TOWN PLANNING BOARD

TPB Paper No. 8859
For Consideration by
the Town Planning Board on 15.7.2011

**Kai Tak Development
Urban Design Enhancement Proposals**

Proposed Enhancement in Connection with Preservation of Lung Tsun Stone Bridge

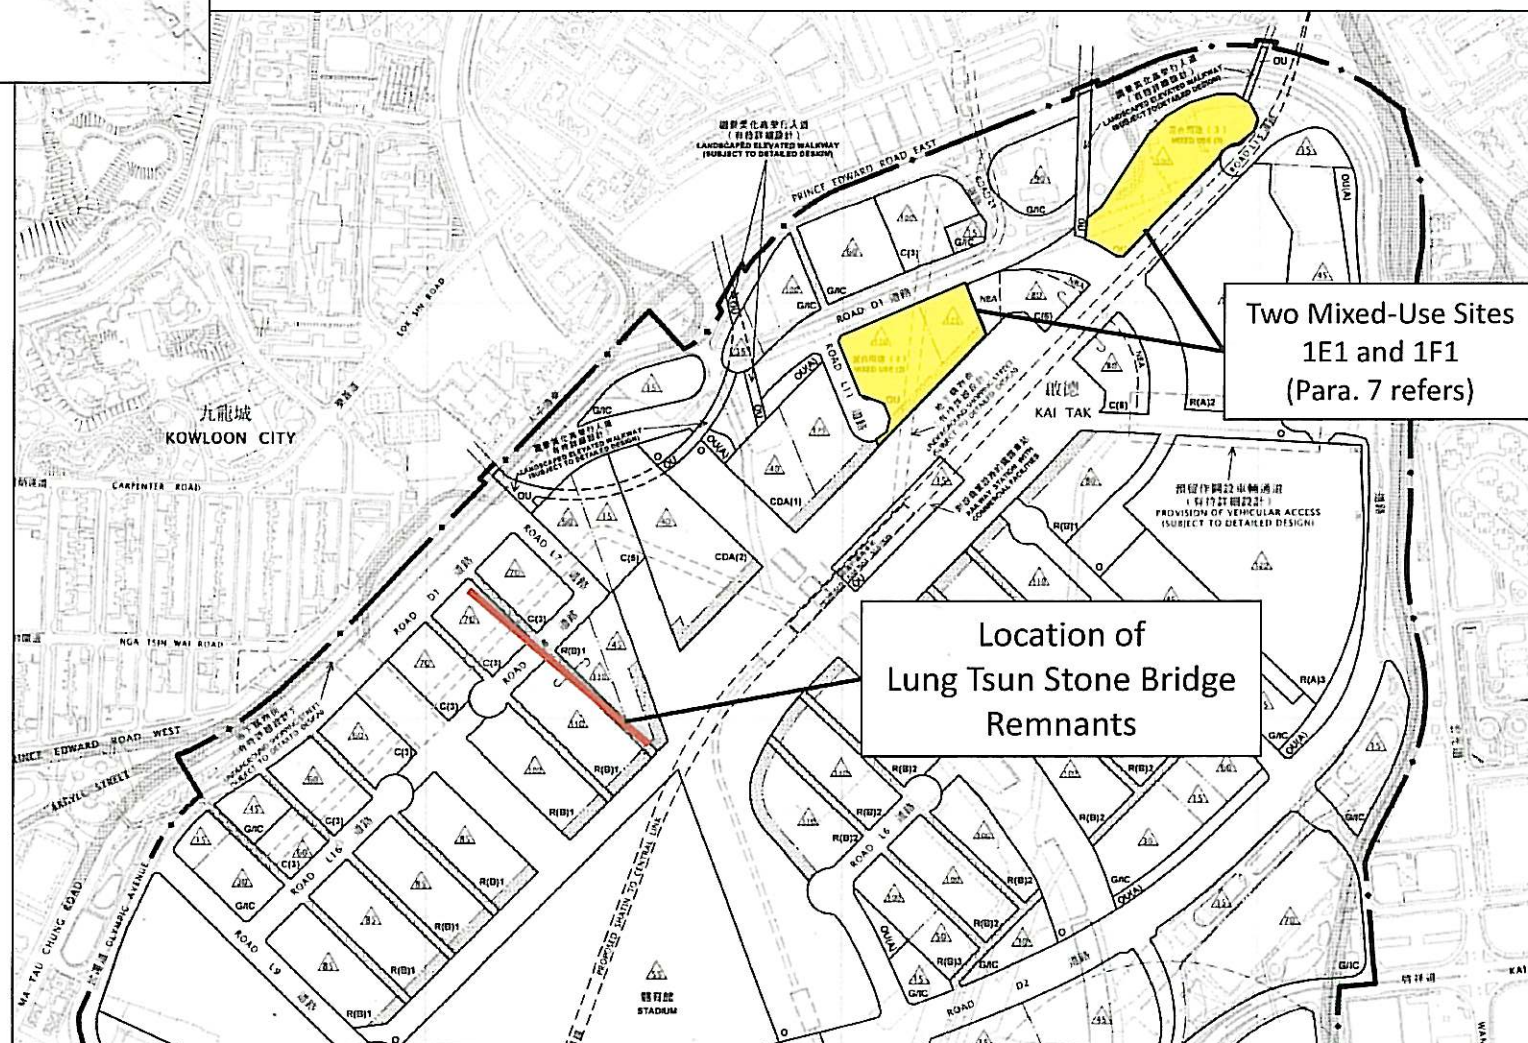
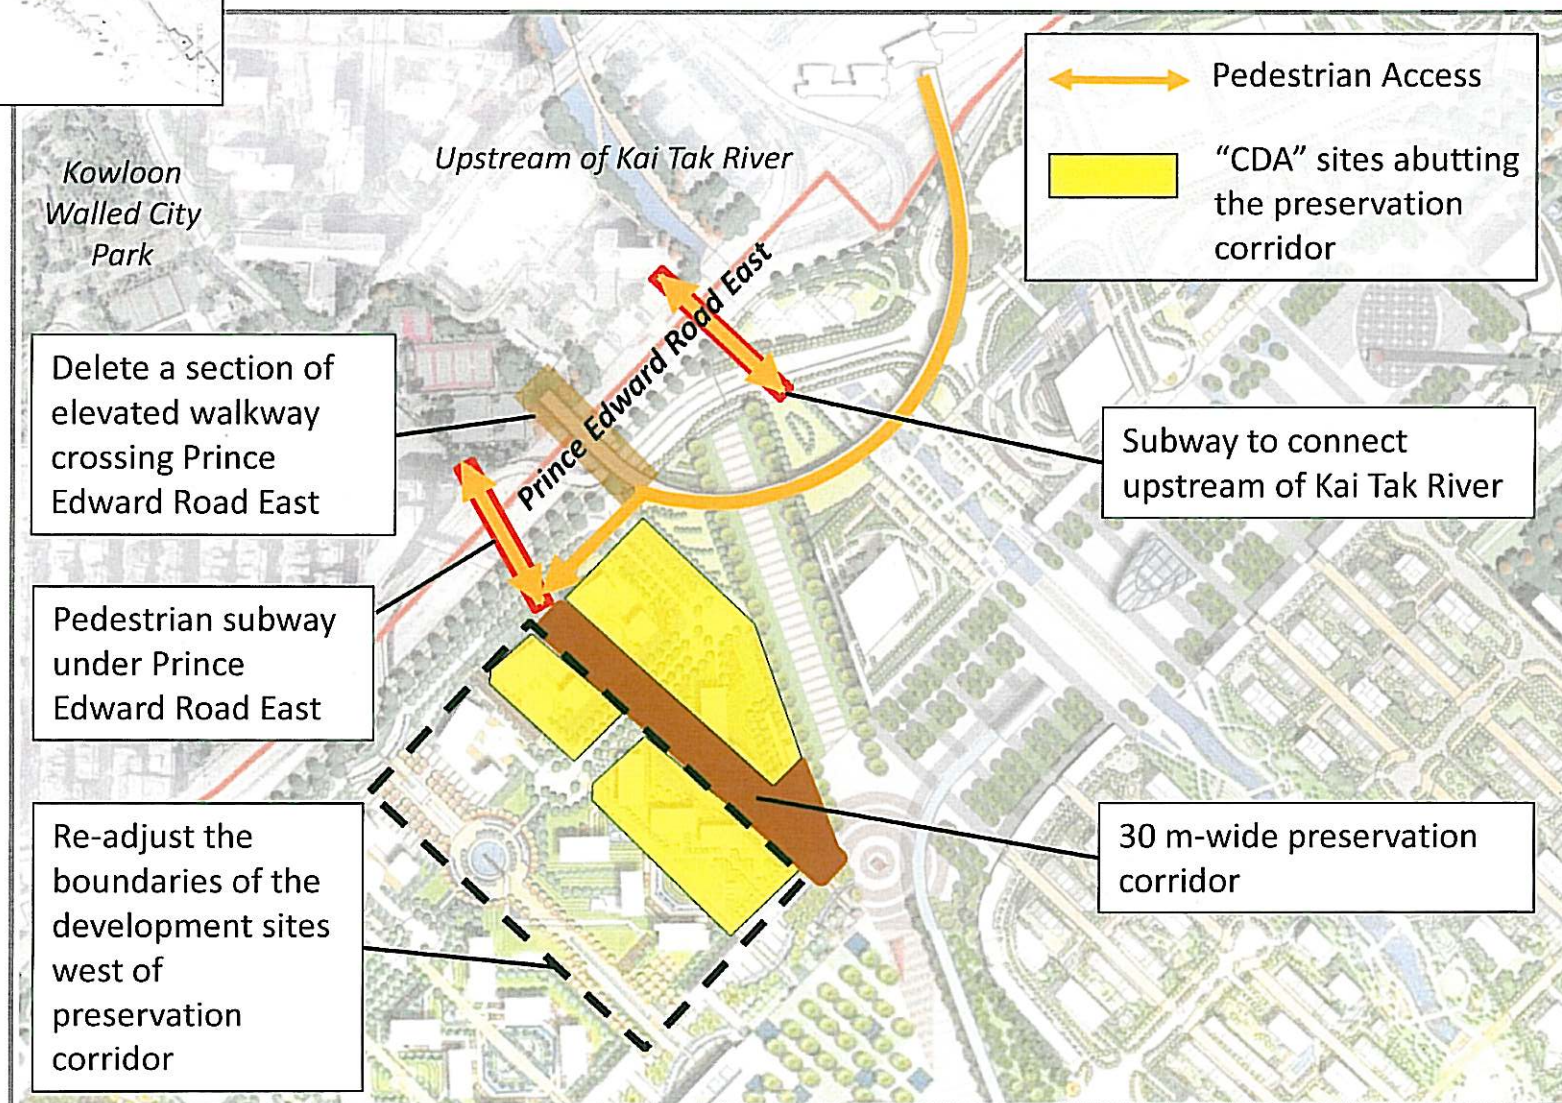
Preservation of Remnants of Lung Tsun Stone Bridge (Annex 1)

4. In response to the public aspirations to preserve the remnants, we conducted a two-stage public engagement exercise from mid 2010 to early 2011 that included site visits, public engagement workshops and consultations with the stakeholders such as District Councils, the Antiquities Advisory Board (AAB) and the Town Planning Board (TPB). To take heed of public opinion and to provide greater flexibility in the interpretation design, we propose to provide a 30 m wide corridor for preserving the remnants (Preservation Corridor) and rezone the entire corridor together with a plaza at its southern end connecting to the Station Square of KTD for “Open Space” (“O”).

5. With a view to providing space for accommodating the Preservation Corridor, we propose to adjust the disposition of three development sites that abut on the corridor. In addition, we propose rezoning the three development sites for “Comprehensive Development Area” (“CDA”) to bring in statutory planning controls for Master Layout Plan submission to the TPB to ensure that the design and layout of these sites will be in harmony with the Preservation Corridor.

6. A dedicated link with heritage theme across Prince Edward Road East (PERE) is proposed to connect the Preservation Corridor with the heritage resources in the vicinity, in particular the Kowloon Walled City Park. On this account, we propose to construct a subway underneath PERE to connect the Preservation Corridor with Shek Ku Lung Road Playground and thence with other heritage resources in the district including Kowloon Walled City Park. Besides, we propose to curtail the PERE section for the planned curvilinear-landscaped-elevated walkway on the approved OZP with a view to rationalizing the pedestrian crossing facilities.

Proposal to Reinforce Gateway Image and Provision of a Large Landscaped and Community Area for Arts and Performance

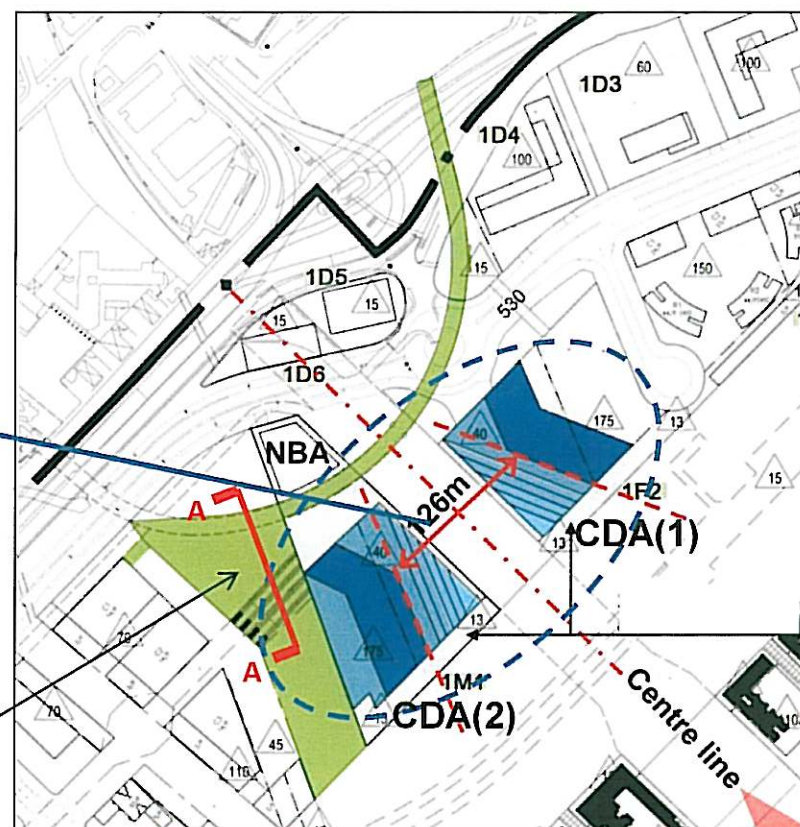
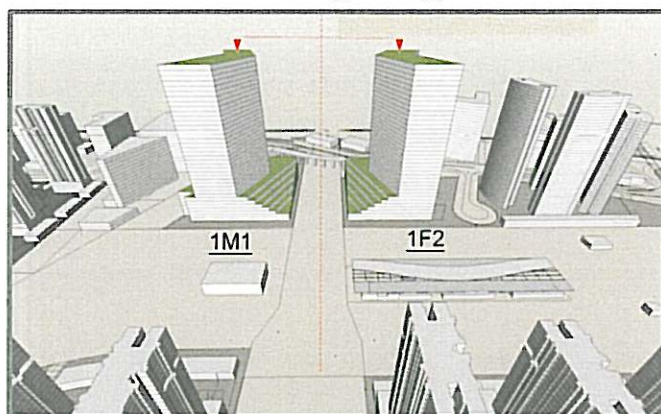
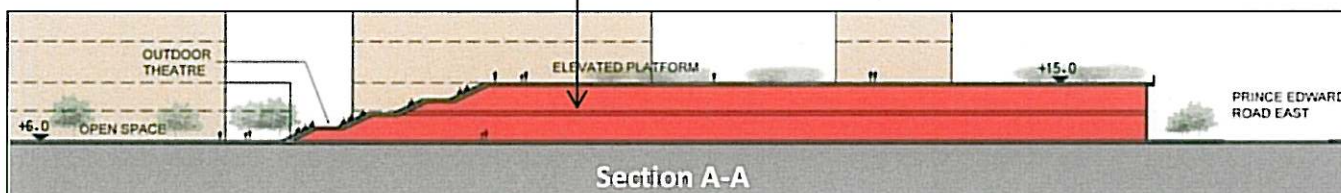
8. In response to curtailing the PERE section of the planned curvilinear-landscaped-elevated walkway, we propose to merge the walkway with a commercial site and rezone it for “Other Specified Uses” (“OU”) annotated “Arts and Performance Related Uses” only providing venues for outdoor art performance and a public viewing platform on the roof top and grand steps down to the view corridor along the Multi-purpose Stadium Complex. The original commercial Gross Floor Area (GFA) for this site will be transferred to “CDA(2)” site west of Kai Tak River (**Annex 2**). Together with the landmark building in the “CDA(1)” site east of Kai Tak River, a twin-tower concept along the Kai Tak River to reinforce the gateway image is proposed. The same development parameters, i.e. a plot ratio of 8 and two building height sub-zones of 40 m and 175 m above Principal Datum, for each site, are proposed.

**Design Concept having Residential
Towers and Low Blocks with a Courtyard
is Adopted at Grid Neighbourhood**

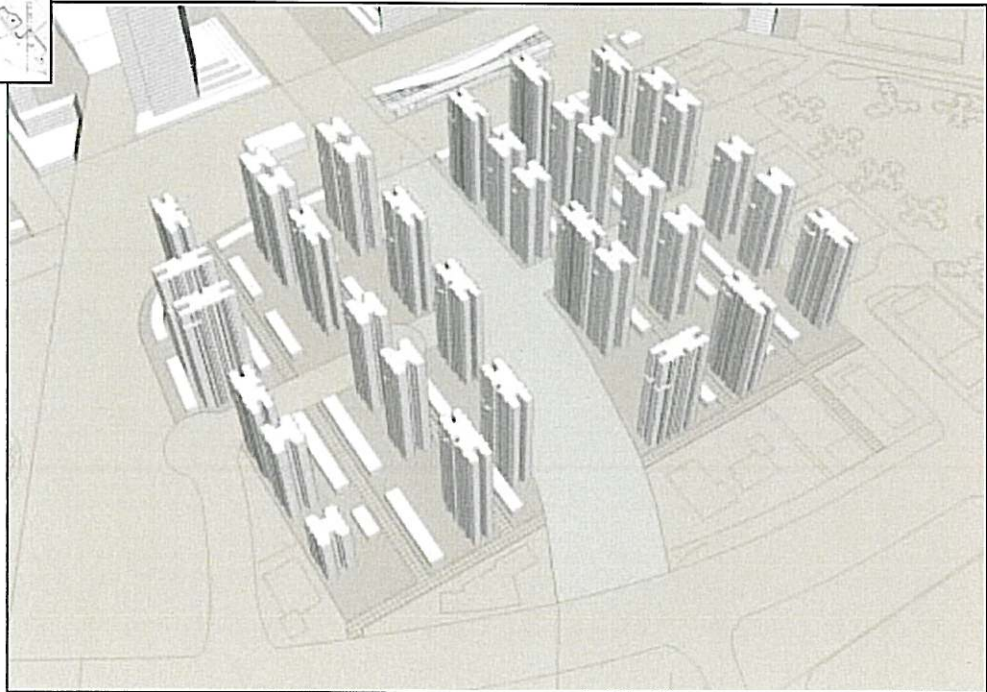
9. For the Grid Neighbourhood sites, the planning intention is to create a distinctive residential neighbourhood with intimately scaled urban street blocks. To manifest the planning intention and to enhance community interactions within the neighbourhood and the pedestrian streets, we propose to enhance visual permeability by refining the massing and disposition of high and low building blocks within the development sites as well as incorporating a courtyard design approach to project a well-proportioned neighbourhood environment and vistas as well as urban intimacy (**Annex 3**). In this regard, the height control along the pedestrian street as specified in the approved OZP is proposed to be refined from not exceeding 3 storeys to not exceeding 6 storeys.

Proposed Alignment of Underground Shopping Street

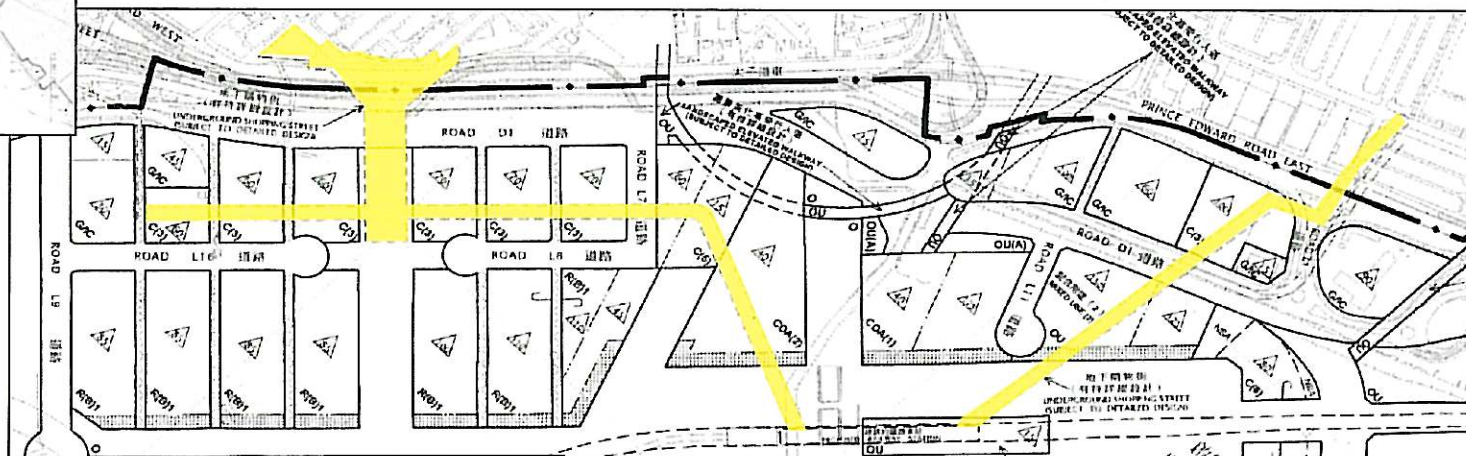
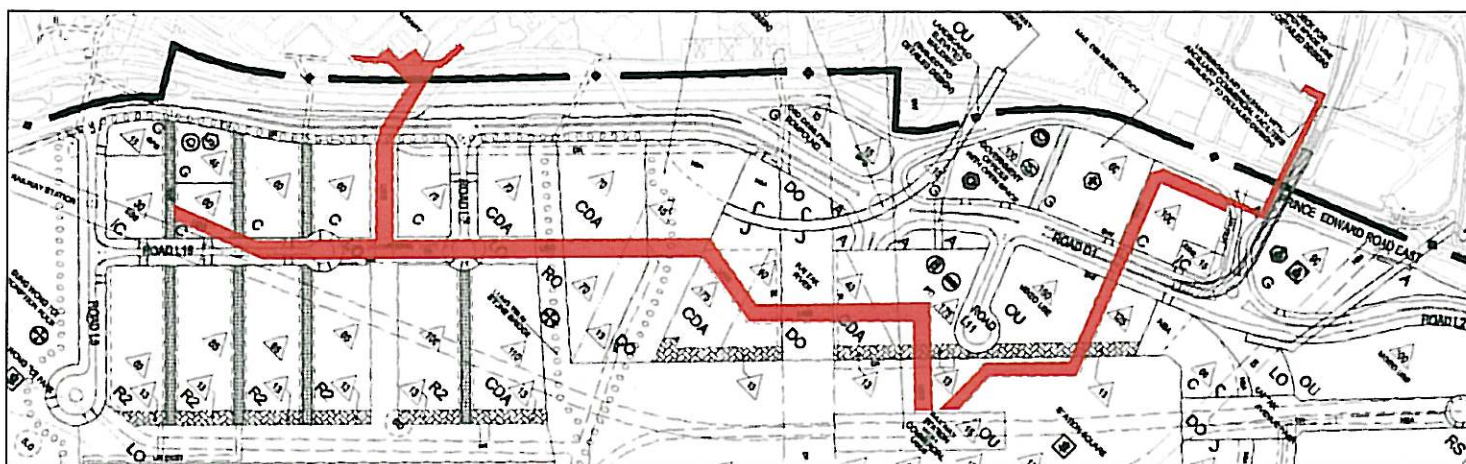
10. In the light of the public aspirations for a landscaped urban river channel running from Wong Tai Sin through KTD to the sea, we propose to construct a new subway across PERE along the Kai Tak River. In addition, the introduction of the Preservation Corridor necessitates adjustments to the boundary of some development sites. We also propose to refine the layout of the Underground Shopping Streets (USS) connecting to Kowloon City and San Po Kong to enhance the connectivity with the surrounding districts and provide flexibility for achieving a holistic design for the USS as well as flexibility in the implementation programme and the future management of the USS (**Annex 4**). With the refinement to the alignment of the USS, we recommend, in addition to the two-storey retail belt along the edge fronting the Multi-purpose Stadium Complex, introducing flexibility to provide retail elements on the ground floor of the residential development along local roads to capitalize on the anticipated pedestrian flow.

Proposed Relocation of Roads and the Associated Landscaped Deck at Runway away from the Waterfront

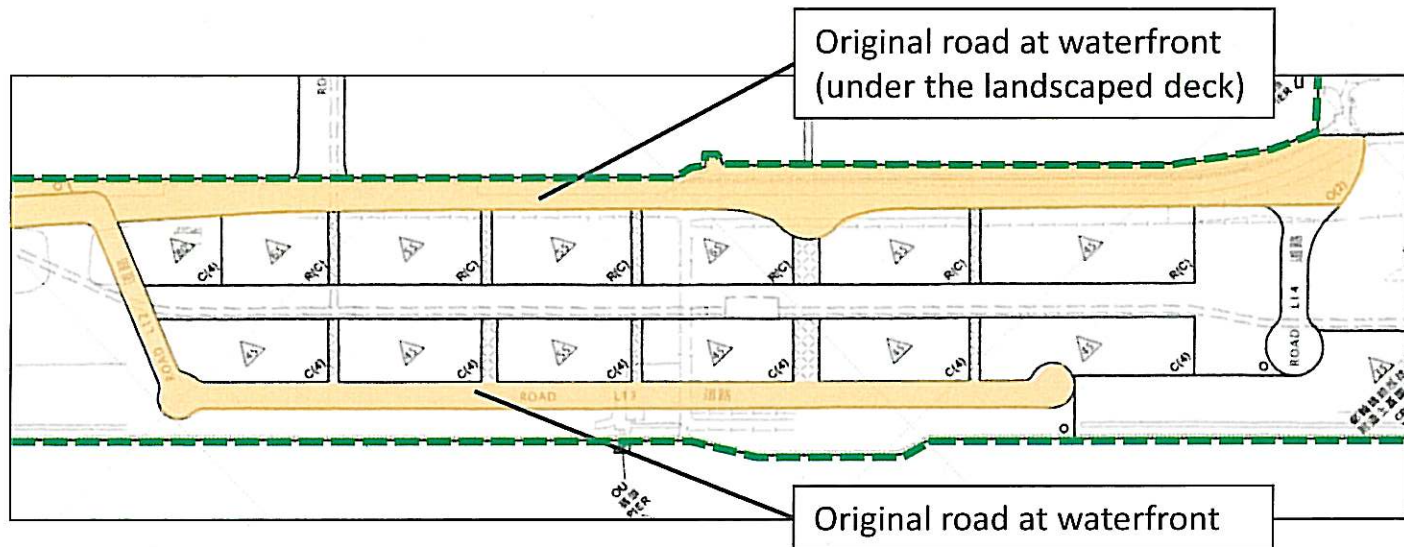
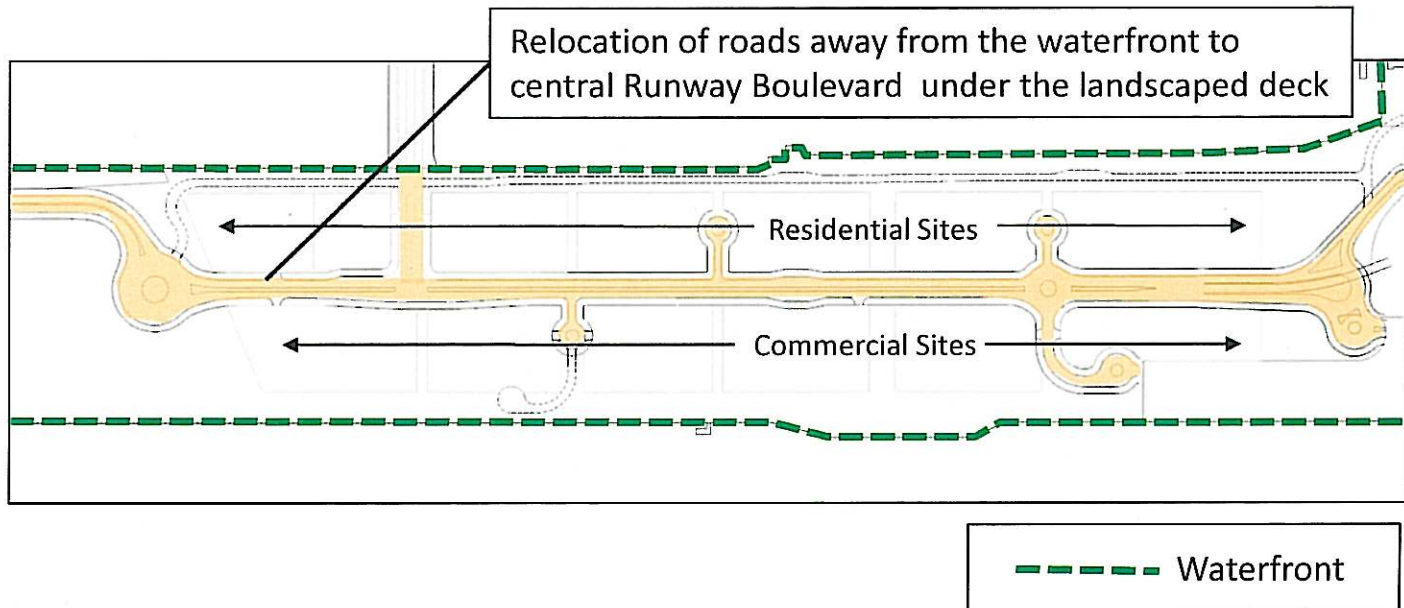
11. We propose relocating two planned roads and the associated landscaped deck away from the waterfront to the central Runway Boulevard so as to enhance public accessibility and enjoyment. Due to the existence of at-grade vehicular connections to the Cruise Terminal and the underground infrastructure for the District Cooling System, the relocated road will be designed as an at-grade carriageway with connections to the planned residential and commercial developments, the Cruise Terminal as well as the Metro Park and the Runway Park. Similar to the original arrangements, a landscaped deck will be provided above the road at the central Runway Boulevard, which will serve as an open space and a walkway, as well as an effective traffic noise mitigation barrier for residential developments along the northern side of the former runway.

12. After the relocation, the area zoned for “Open Space” and the total width of the north and the south promenades will be similar to that shown on the approved OZP.
